ADDENDUM ONE

Project Number: 23-031
Project Name: A New Classroom Addition for
Davis Elementary School
Addendum Release Date: February 8, 2024

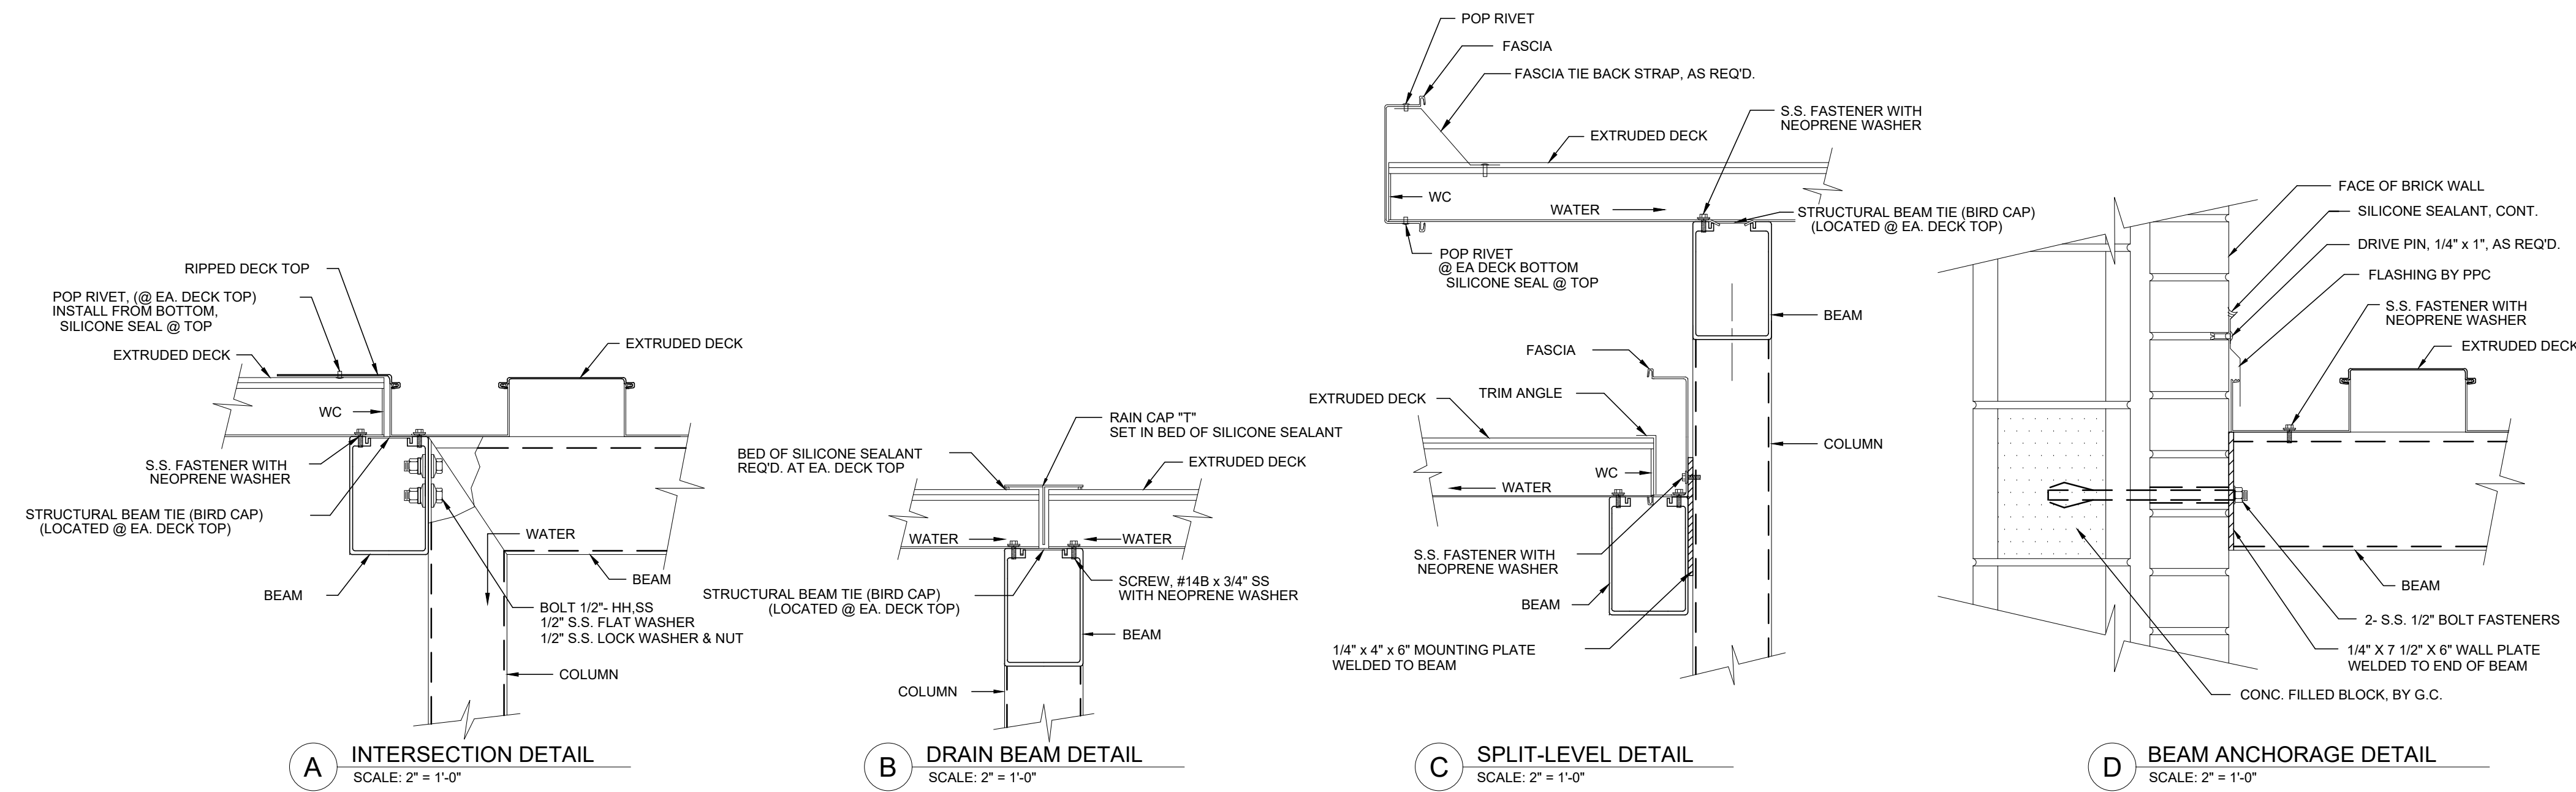
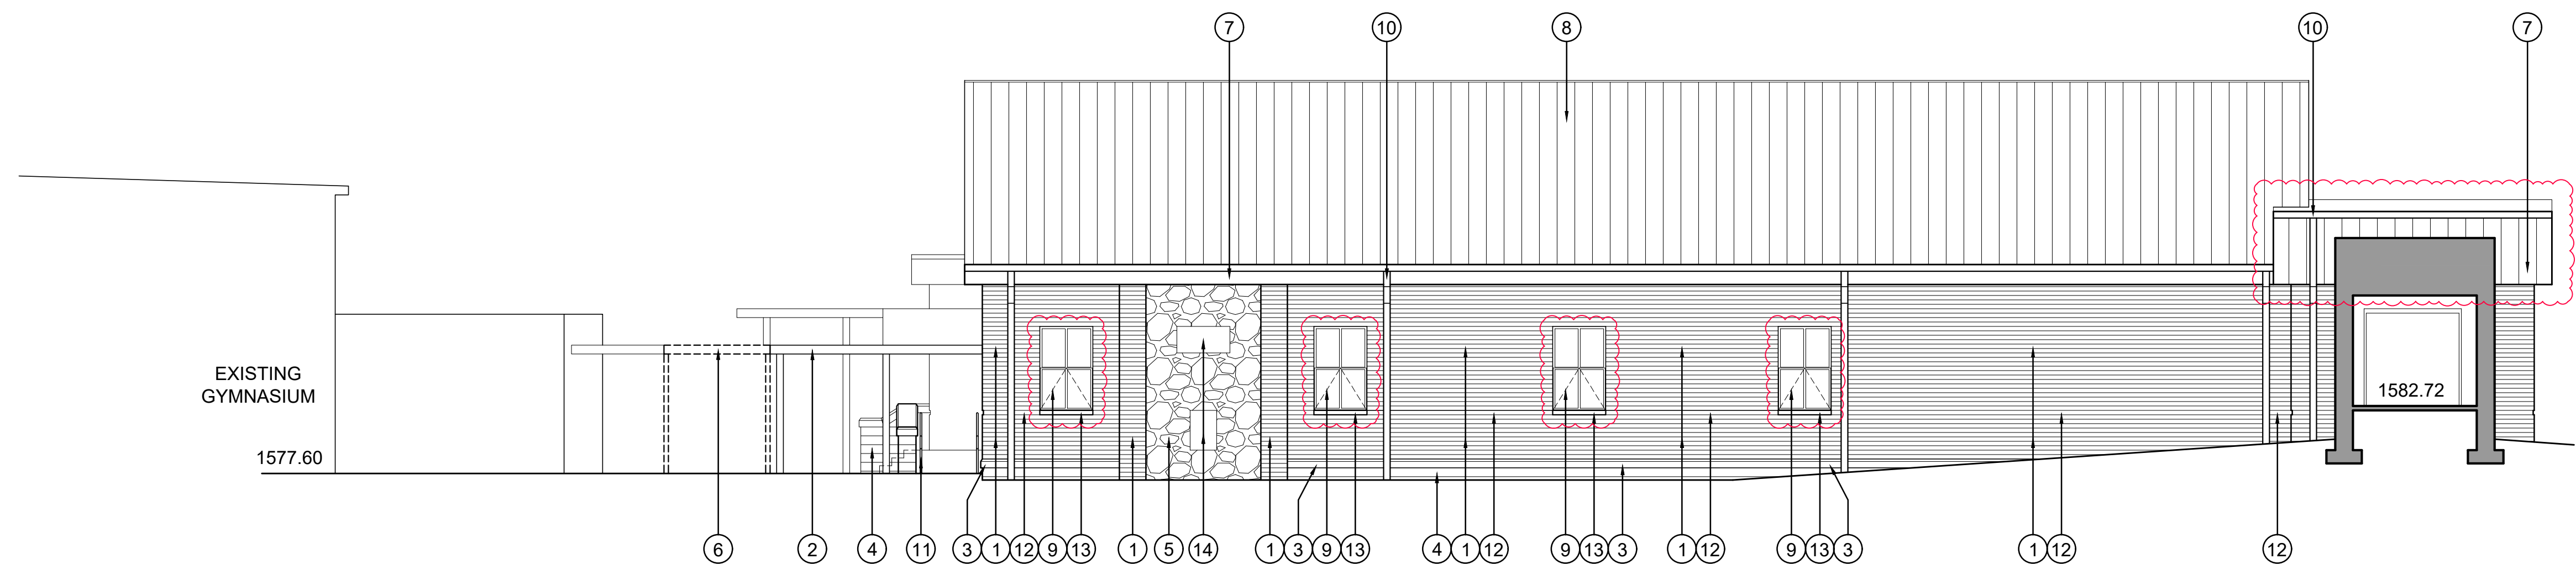
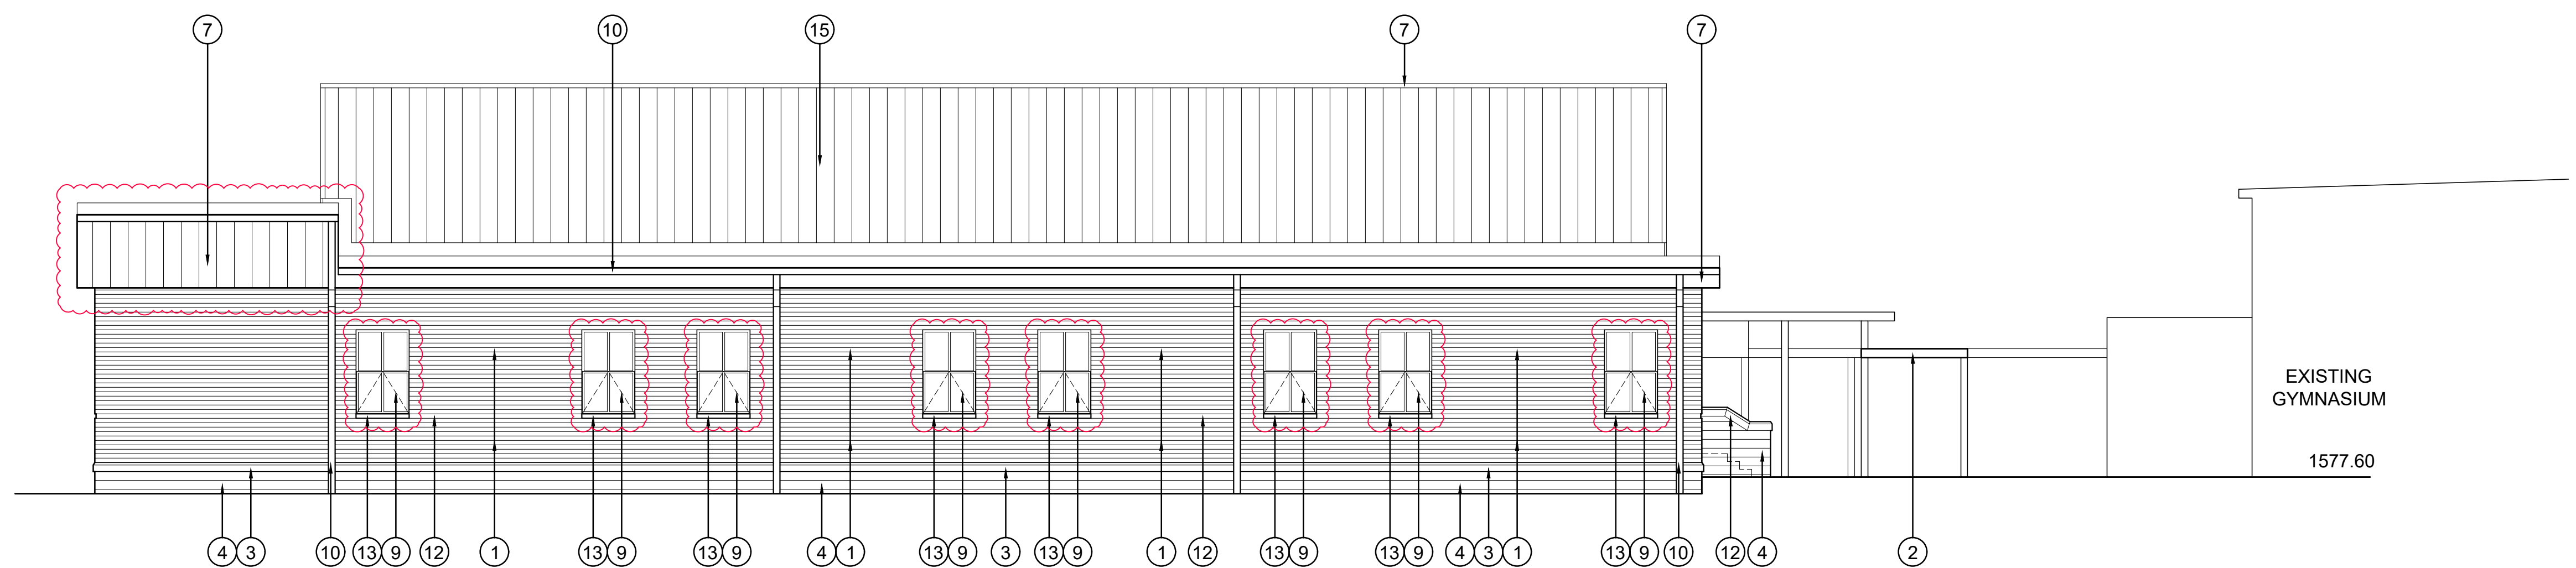
18. Reference Section 04200: there is no reference to Stone in this section. However, Detail 1/A2.1 Note 5 shows Reclaimed Rubble Stone and Detail 1/A4.1 shows Reclaimed Natural Stone. Please provide requirements and/or source for Stone material.

32. On drawing A2.1, Materials Legend #14 indicates “Existing Stone Monument Signs”. Are these signs existing or are they new signs that need to be furnished and installed by the contractor?

Response: Stone material is present on site. Install as shown in sections.

Response: These signs are existing and shall be installed by the Contractor in the new locations shown.

4 WALL SECTION
SCALE: 1" = 1'-0"

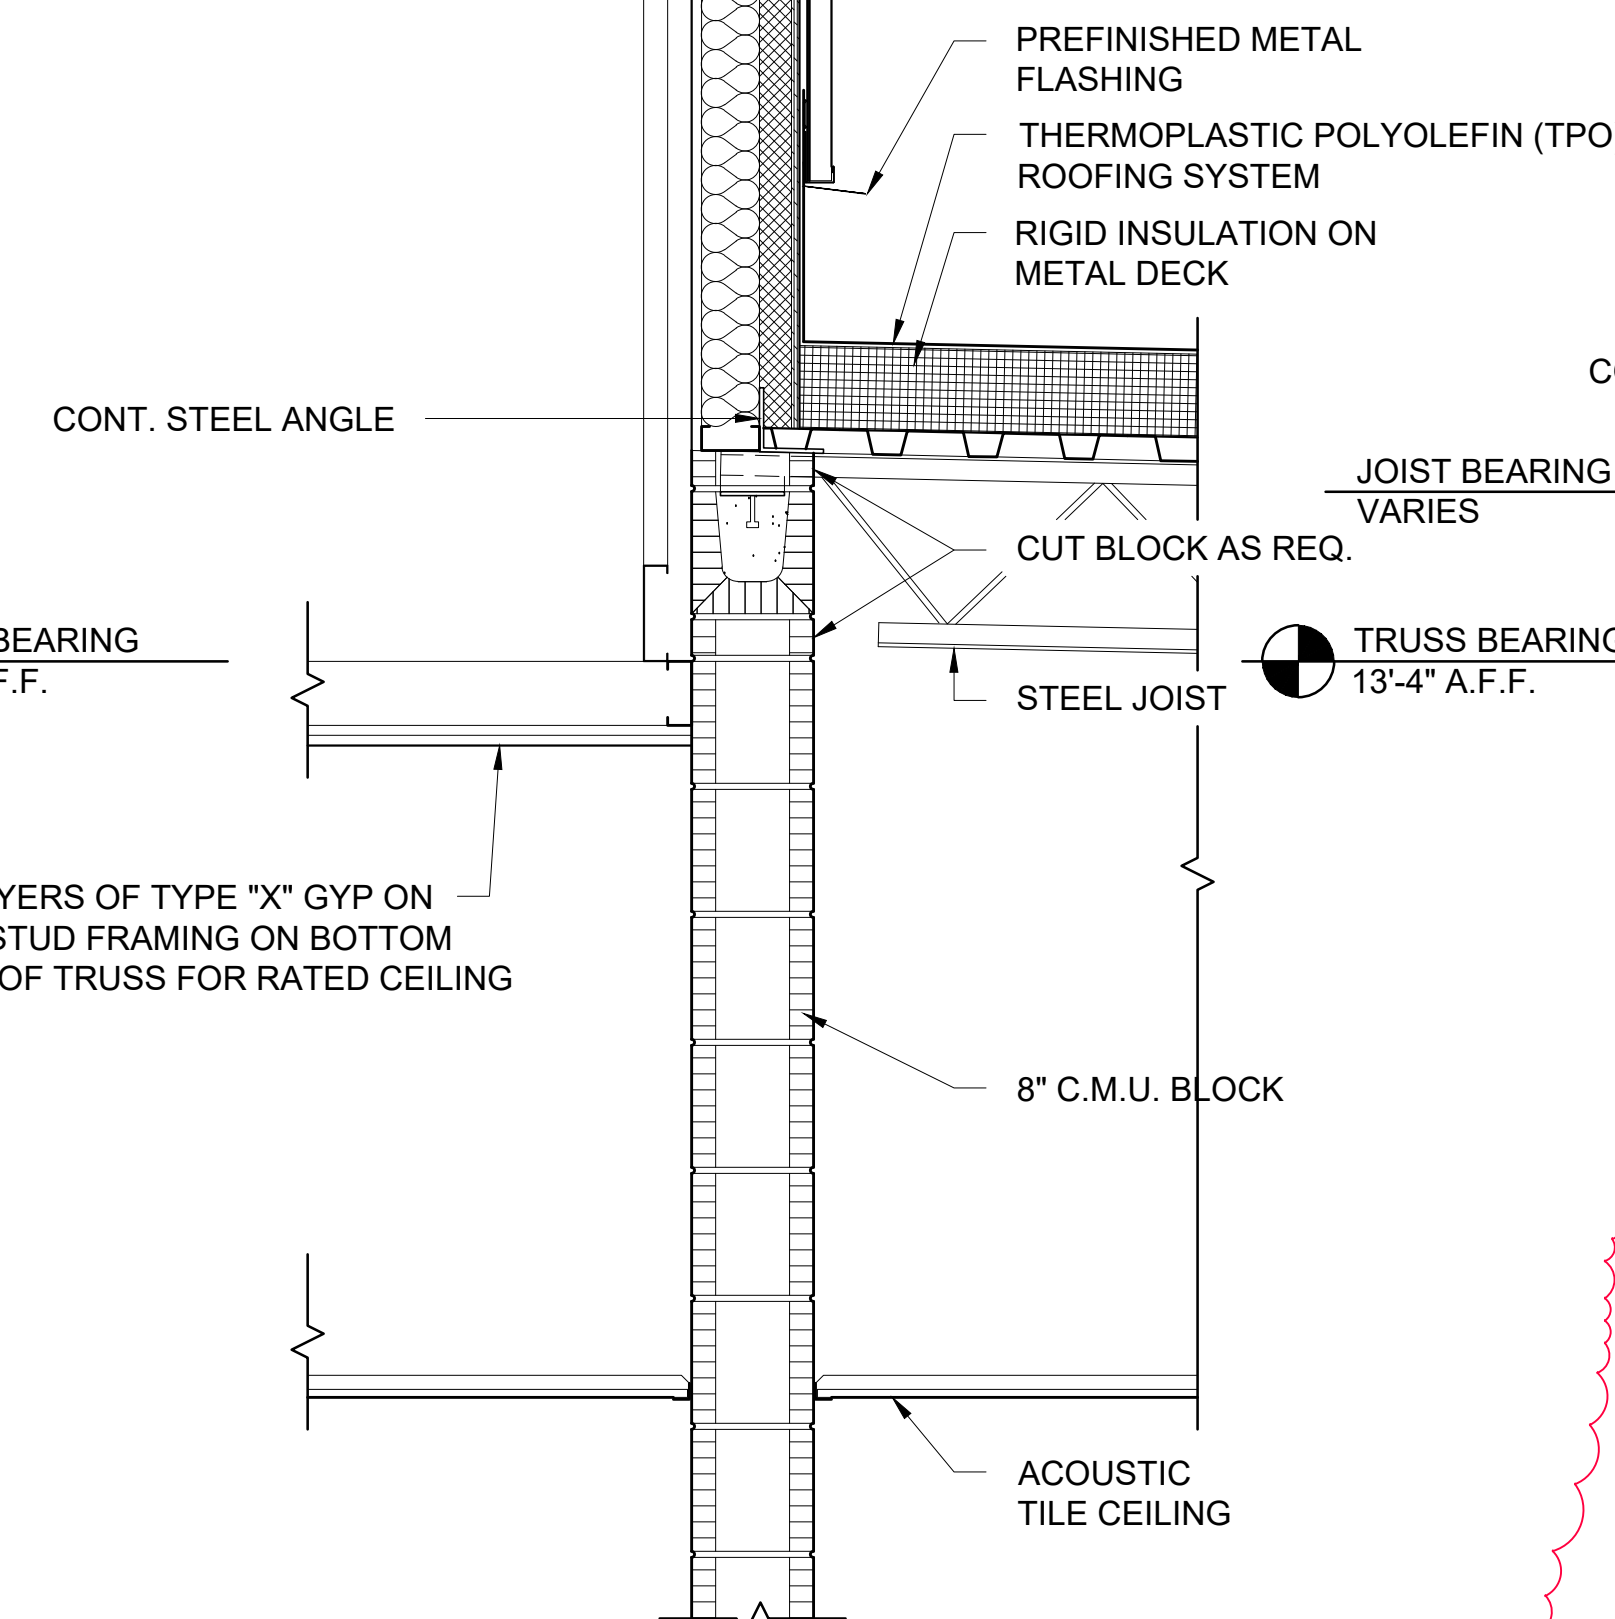
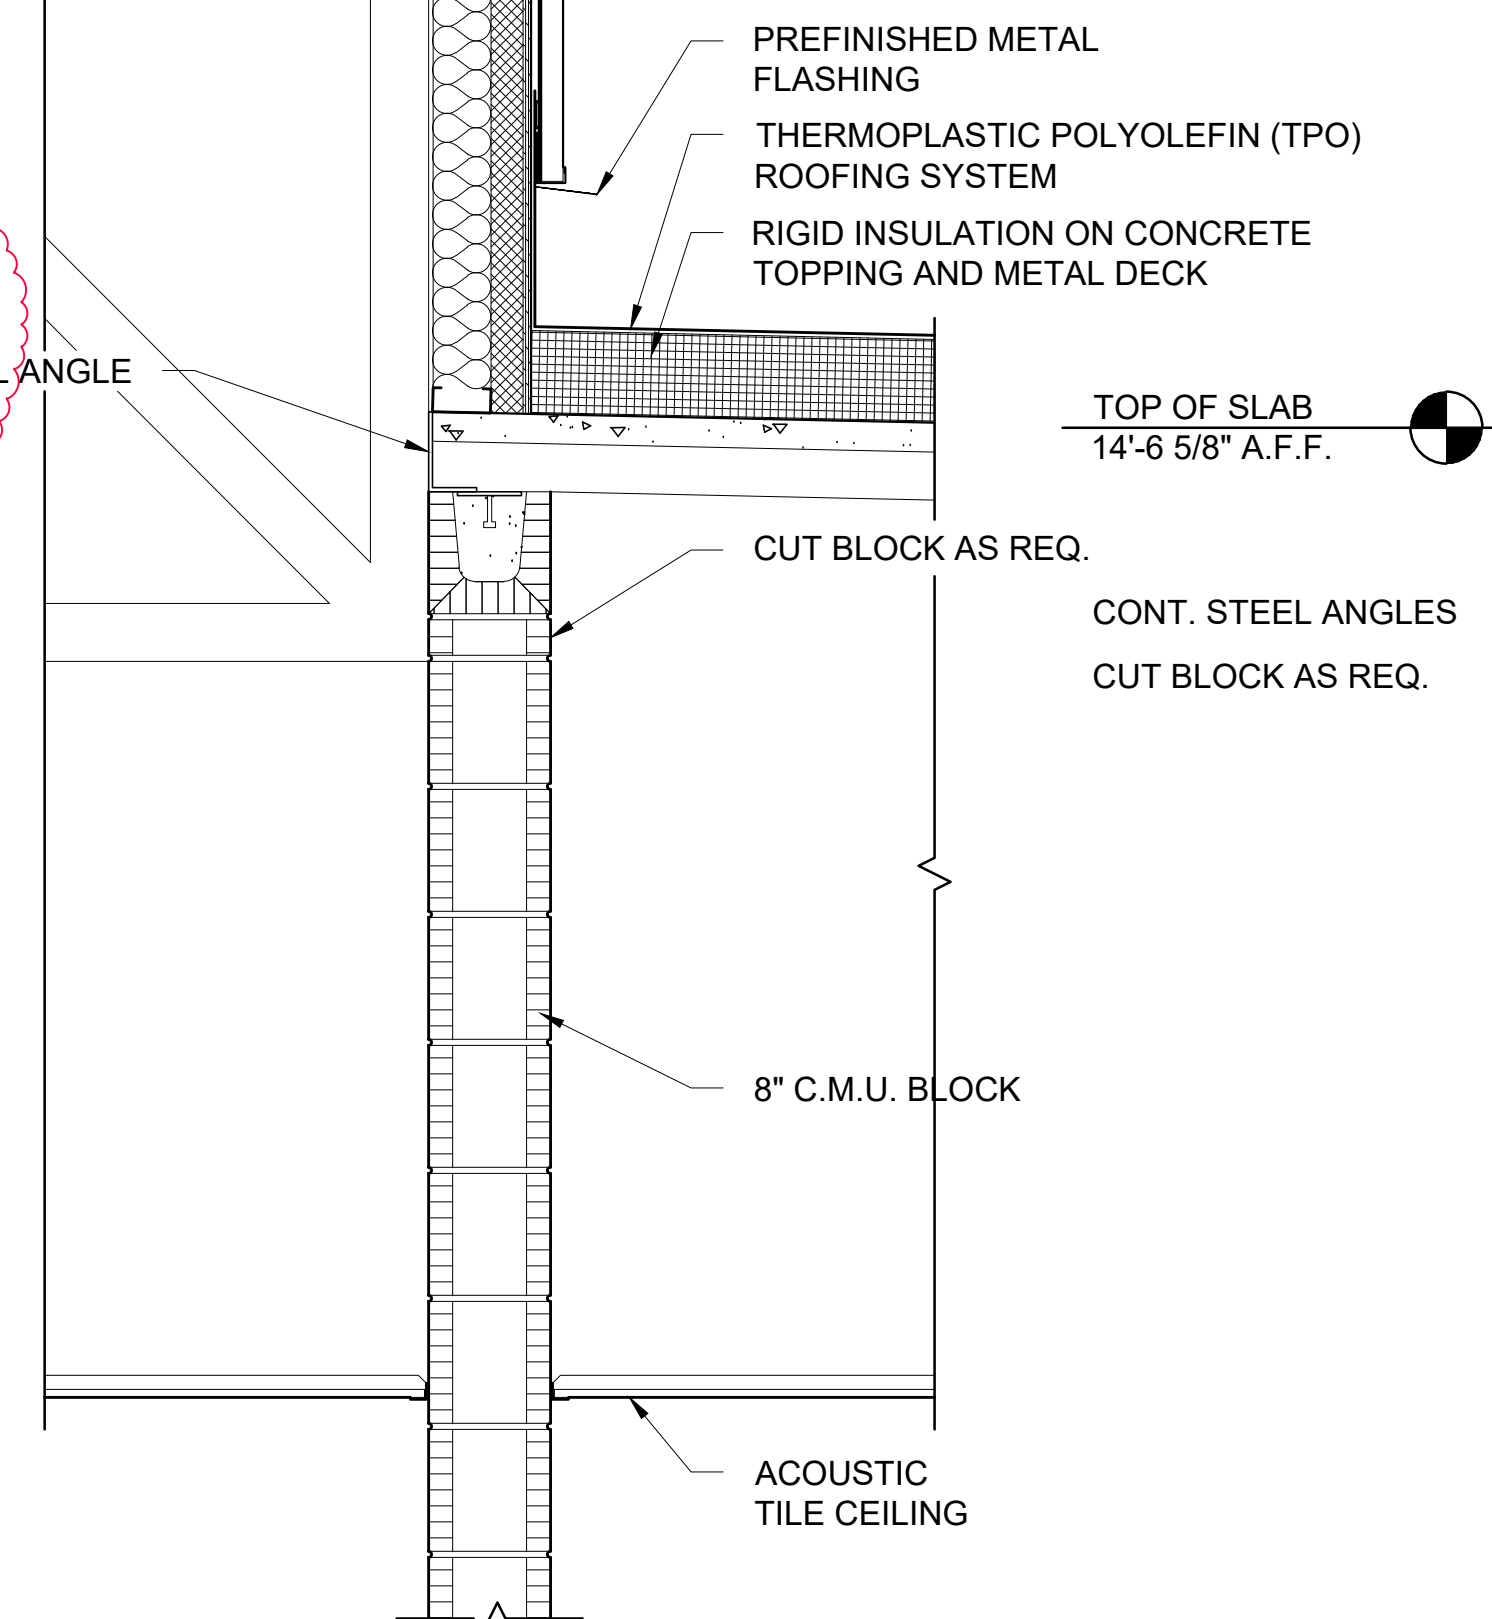
25. Please reference Detail 4/A4.3 and 5/A4.3: should the construction of the walls at these locations be similar?

26. Please reference 5/A4.3: appears to have metal stud framing on exterior side of light gauge metal trusses, though this is not spelled out. If metal stud framing at this location, is it necessary to have two layers of Type "X" Gyp on each side of metal stud framing to continue rated wall assembly to roof deck similar to Detail 4/A4.3? Reference Detail 4/S3.2 (same location as Detail 5/A4.3): 7/8" OSB Sheathing w/edge fastening @ 6" OC and field fasteners @ 12" oc (typ above main roof deck) blocking at 4'0" oc max. Please clarify if exterior wall at this location is to be built per Detail 5/A4.3 (revised??) or 4-S3.2.

Response: These sections have been updated by Addendum 1.

Response: These sections have been updated by Addendum 1.
